STOCKTON UNIFIED SCHOOL DISTRICT

Expanded Learning Opportunities Program (ELOP) - Relocatable Classroom Buildings

The following additions, deletions and revisions to the plans, specifications and Addenda shall become a part of the plans and specifications. It is the responsibility of the General Contractor to submit the information contained in this addendum to all subcontractors and suppliers. The Bidder shall acknowledge receipt of the Addendum in the Bid Proposal. (Addendum number of pages: **32** pages + **77** attachments = **109** total pages).

AD1-TAY-A201

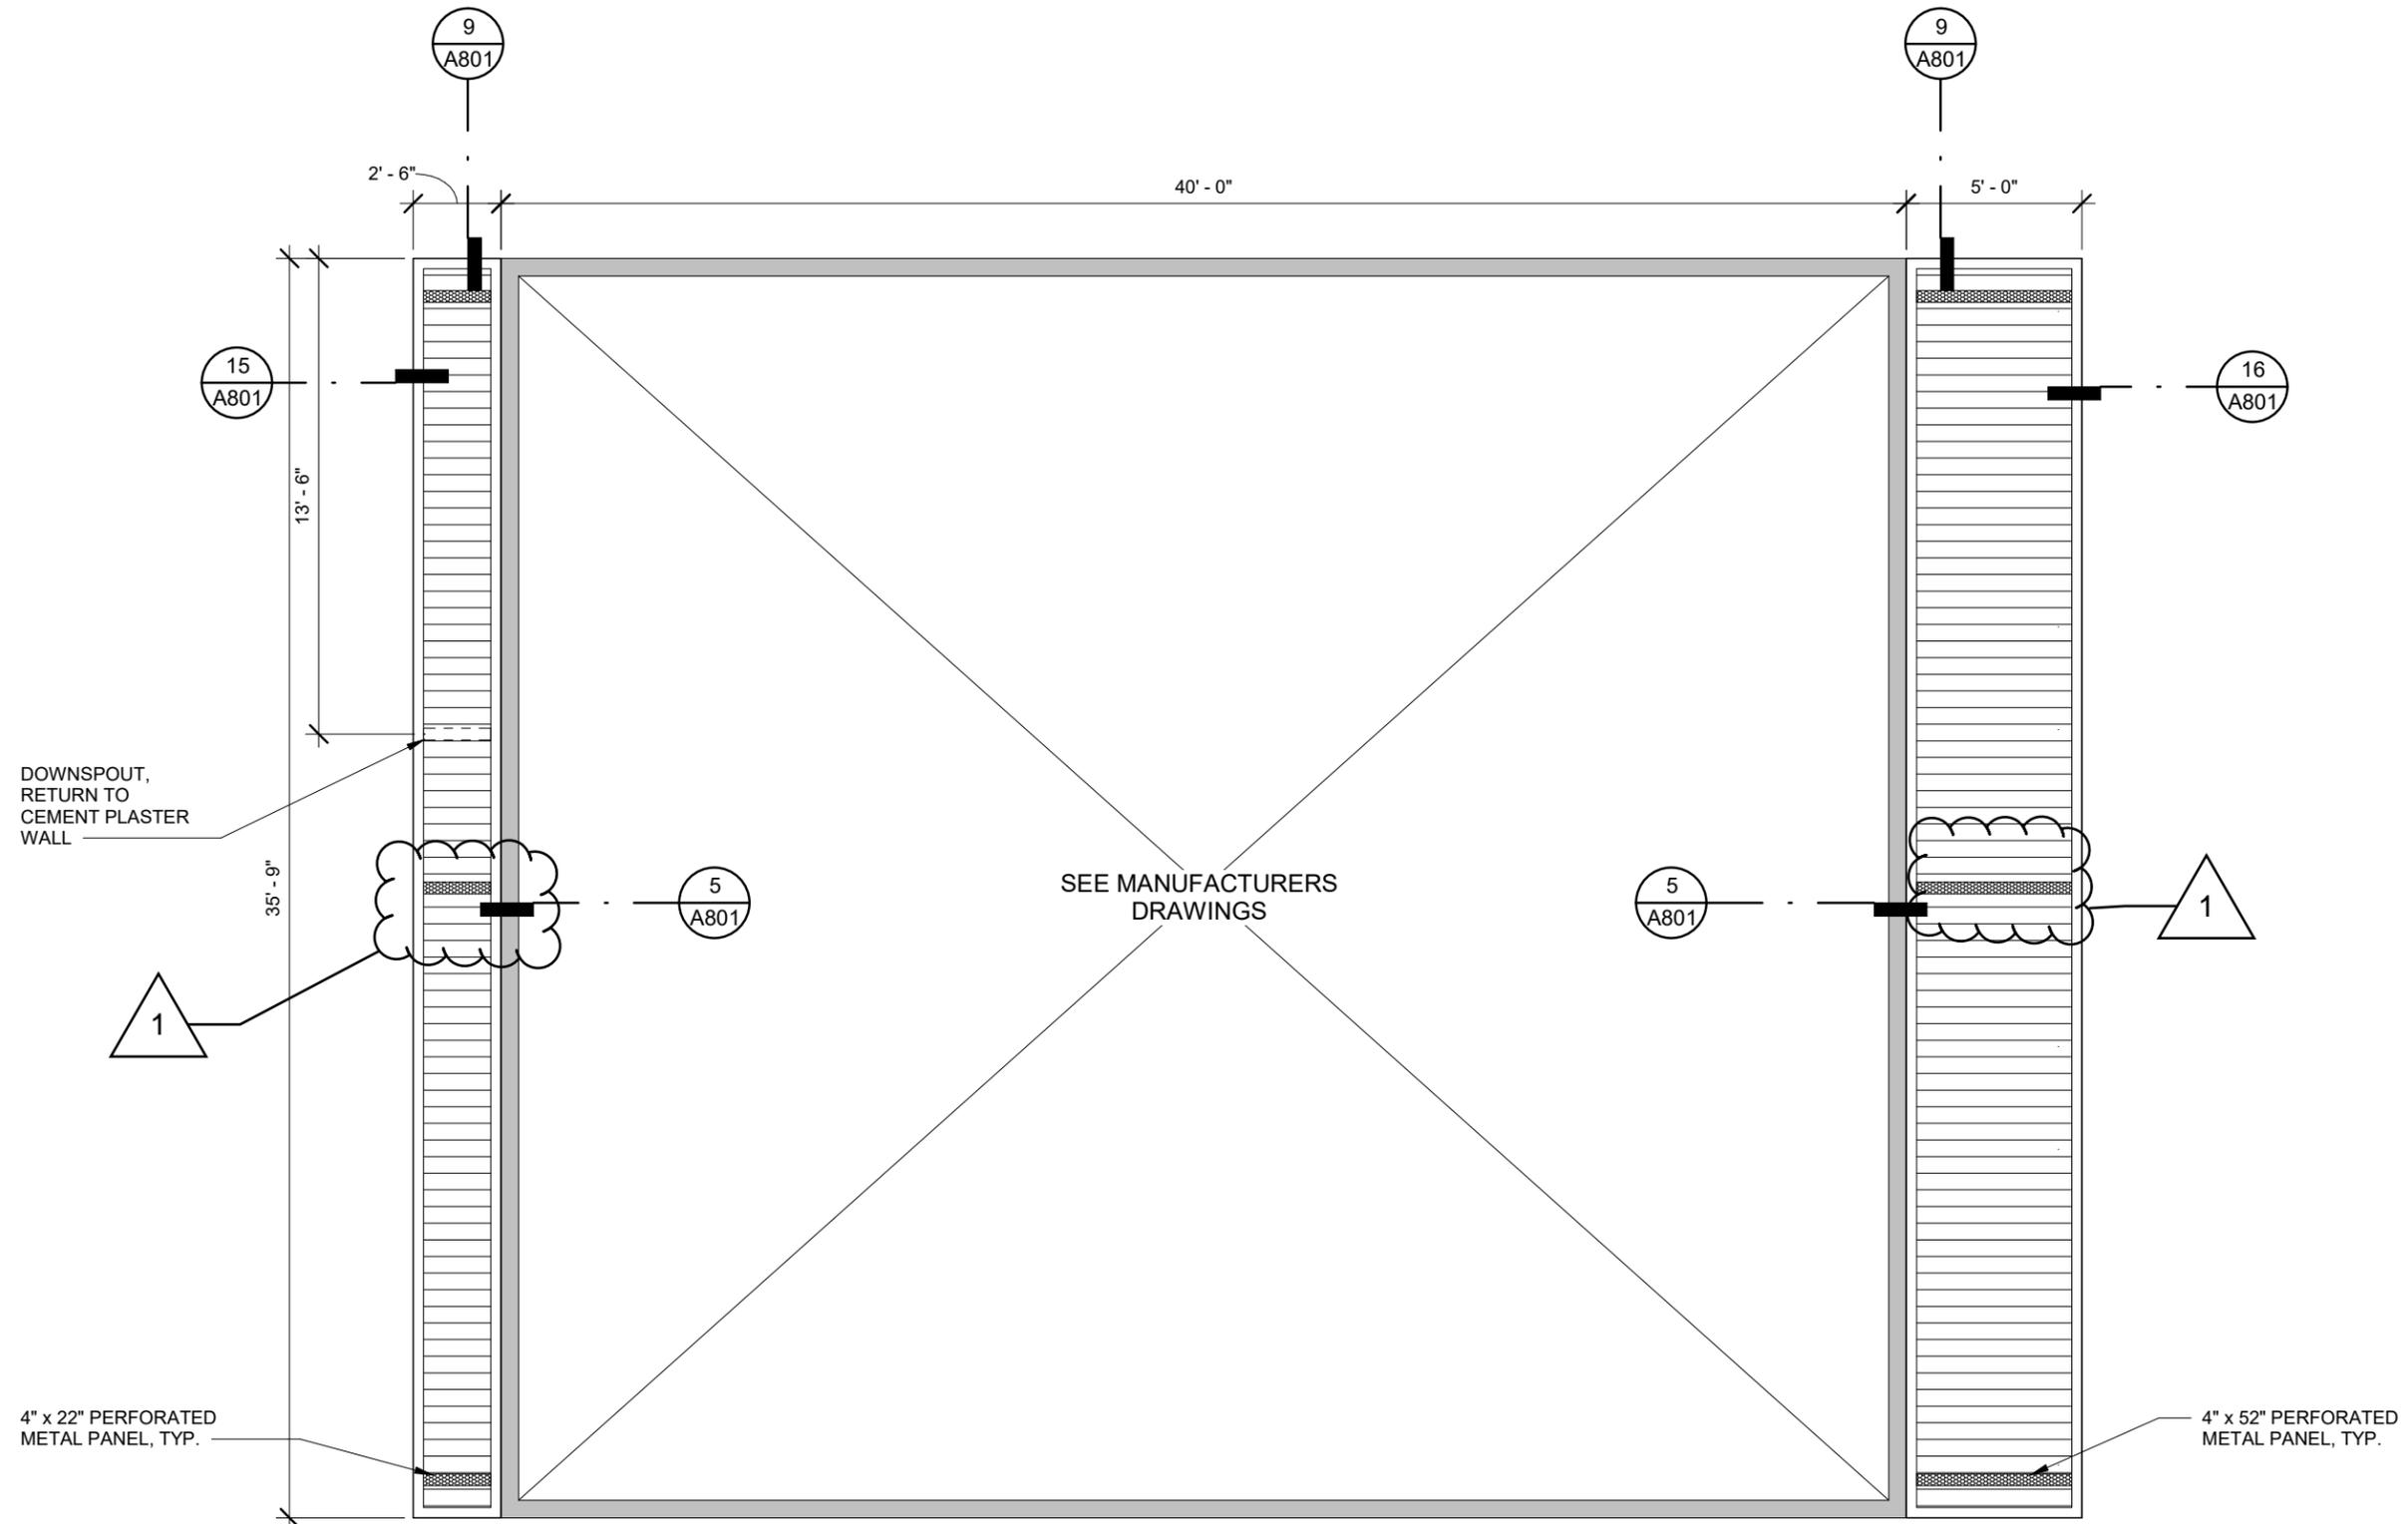
1 - 022: DRAWINGS, SHEET A201 – “PLUMBING FLOOR PLAN”, revise as follows:A. Per attached drawing **AD1-TAY-A201.**

1. Detail 1 has been revised.

AD1-PUL-
A201

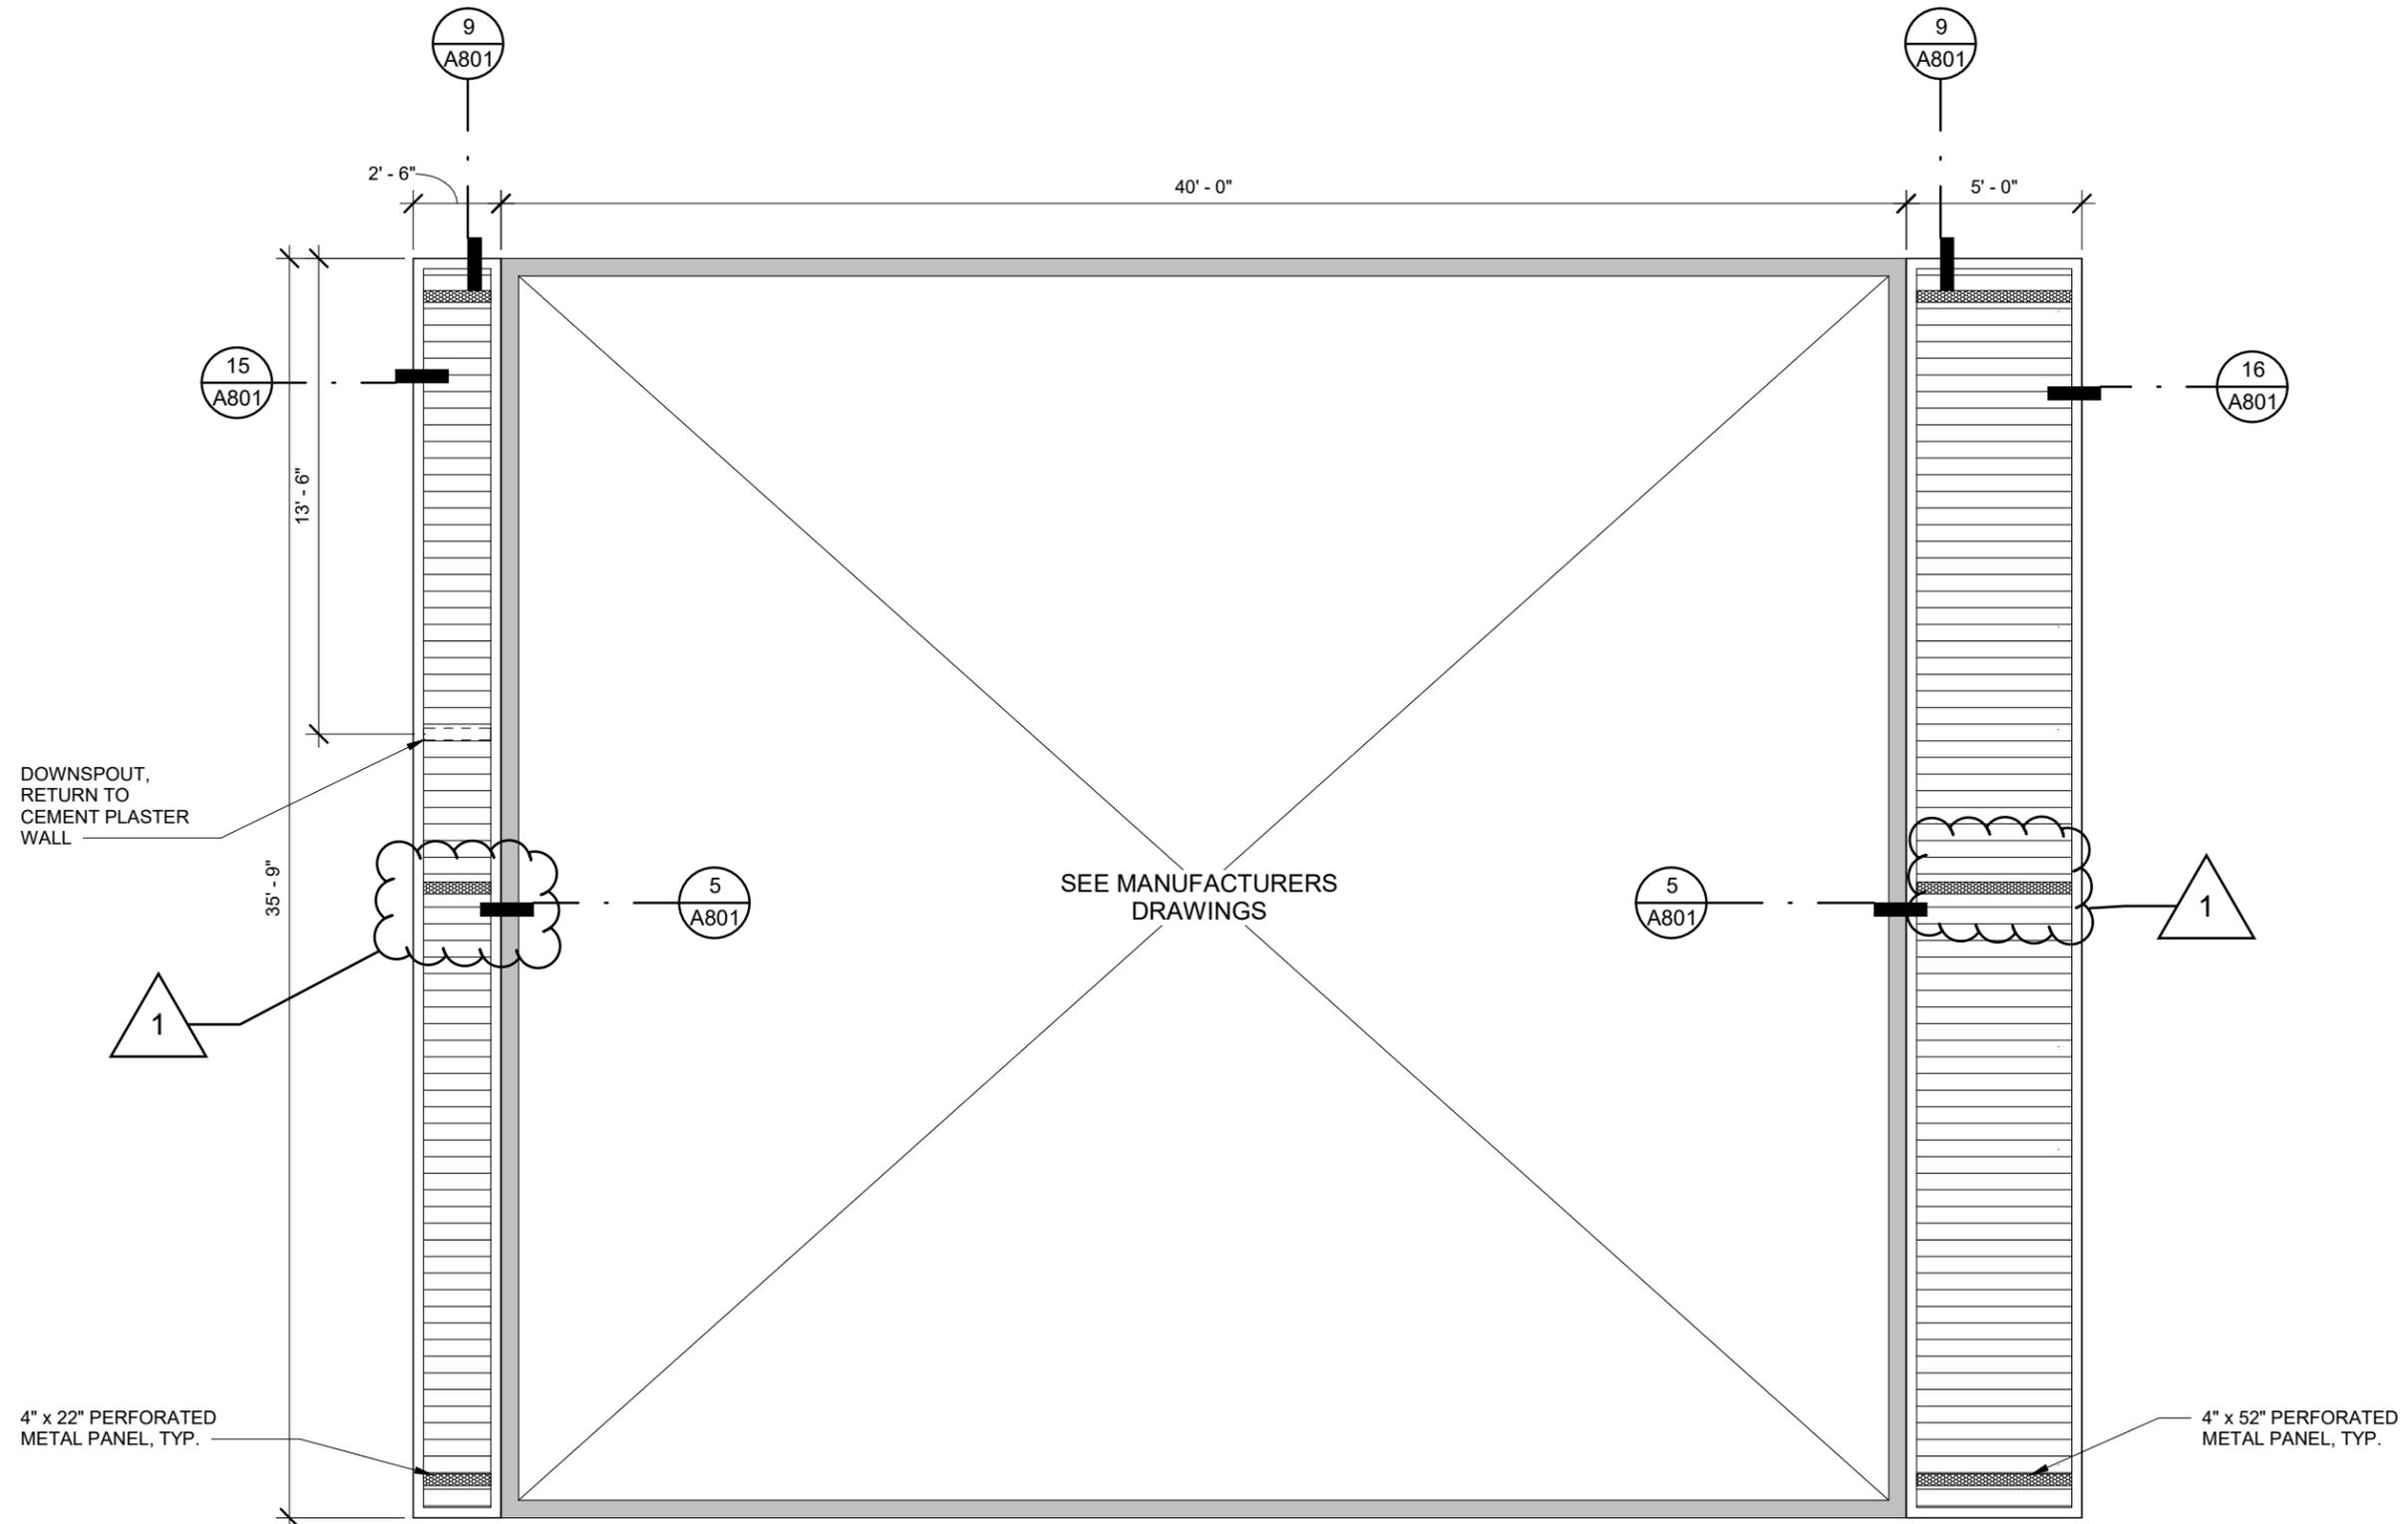
- 1 - 034: DRAWINGS, SHEET A201 – “PLUMBING FLOOR PLAN”**, revise as follows:
- A. Per attached drawing **AD1-PUL-A201**.
 - 1. Detail 1 has been revised.
